TOWN OF WELLS, MAINE
PLANNING BOARD

Meeting Agenda
Monday, March 9, 2026, 7:00 PM
Littlefield Meeting Room, Town Hall
208 Sanford Road

Sheet No.: C2.0

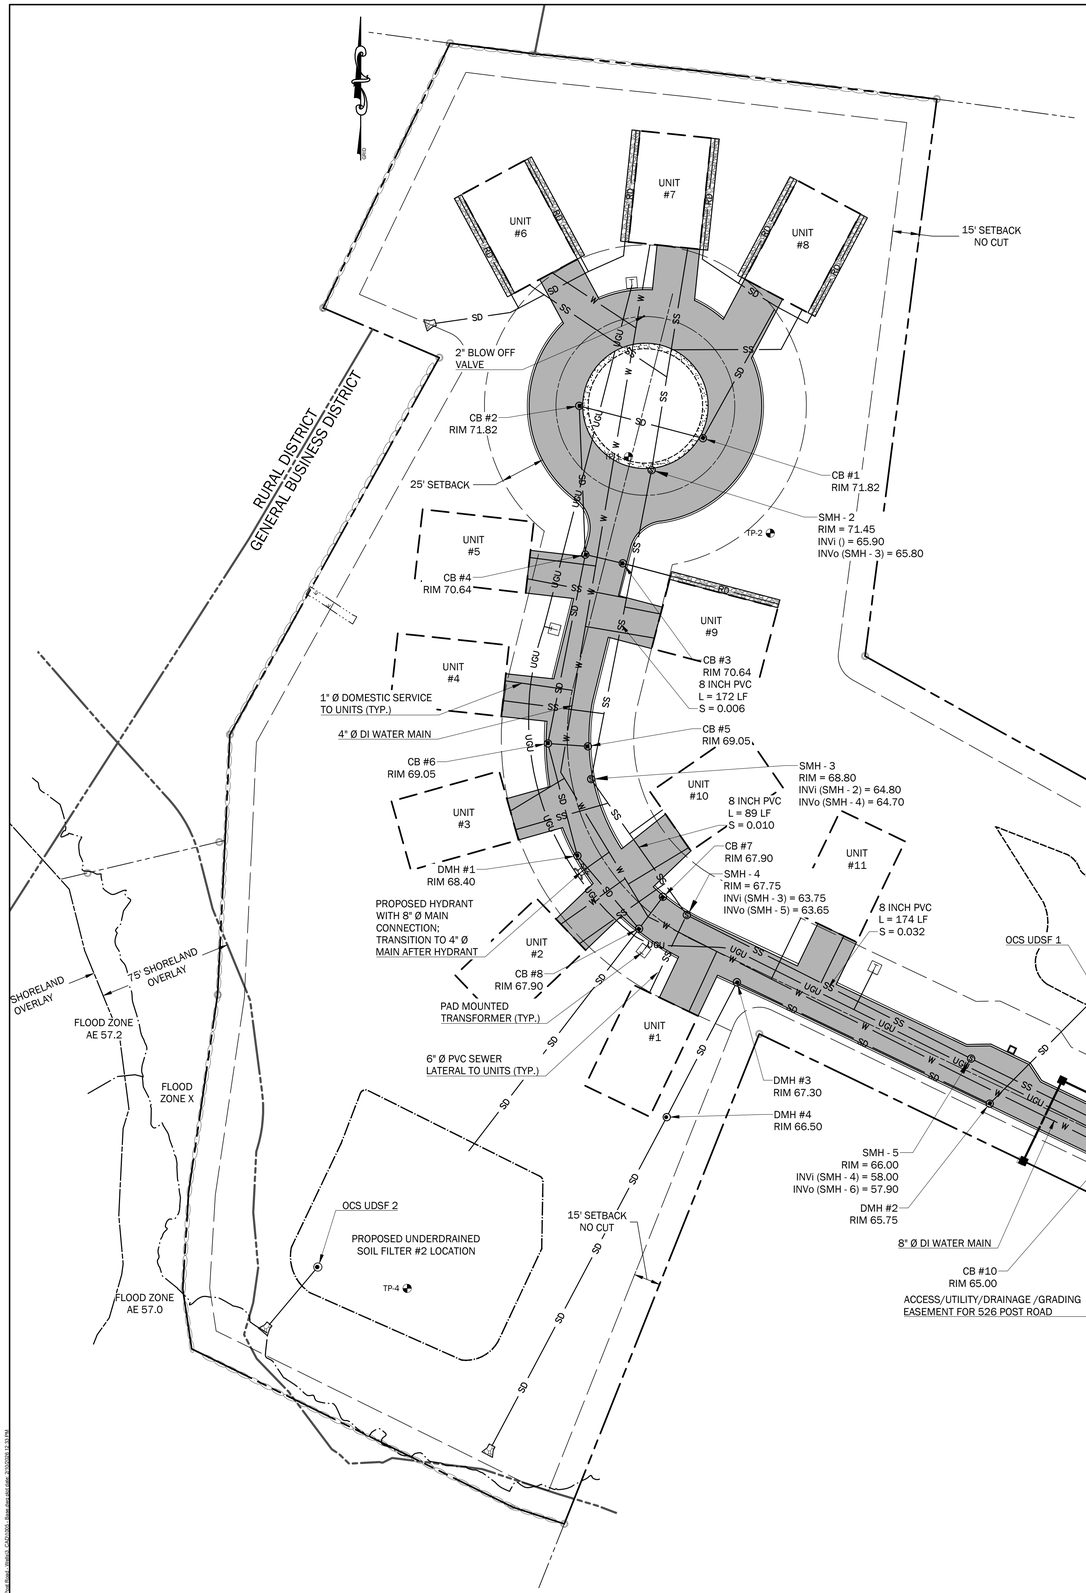
xiv. Are the 2,500 square feet boxes on the plan building envelopes or exact building footprints? Will decks, porches, patios, generators, sheds, fire pits, HVAC units, etc. be allowed for each unit? If so, lot coverage to facture. The 2,500-square-foot boxes shown on the plans represent approximate building envelopes that cap the building, deck, porch, generator, HVAC, and other impervious features at 2,500 square feet per unit. Lot-coverage calculations are based on this maximum; actual as-built coverage may be less but will not exceed the 2,500-square-foot allowance shown on plan C2.0.

F.(6).a. [3]	Twenty-five feet from any lot line abutting any street right-of-way.	**Parcel does abut the Arundel Lane ROW. 25' setback to be identified.**	Y	C2.0	Proposed 25' setback off of Arundel Lane ROW has been added.
145-48	**PERFORMANCE STANDARDS - MULTIFAMILY DEVELOPMENTS**				
A.(1)	A landscaped buffer the width of the required setbacks of Article V along all lot boundaries shall be required. The buffer strip shall not contain parking areas or structures, but may contain a perpendicular access driveway(s) or road(s) to connect with existing streets	15' wide landscaped buffer along all lot lines noted. **Label corrections needed.** Arundel Lane roadway serving the multifamily development crosses the buffer required from the street ROW.	Y	All Sheets	Labels for the proposed 15' landscaped buffers for the multifamily development have been updated accordingly on all sheets.
A.(4)	One-family dwelling structures shall be separated by at least 30 feet.	**Single family dwellings shall be separated by a minimum of 30 feet. Measurements between the units on the plan appear to be 28 or 29', not 30'.** **Plan provided is not to scale.**	Y	All Sheets	Confirmation that all building envelopes are separated by 30 feet. Plans have been printed with correct margins to provide accurate scale.
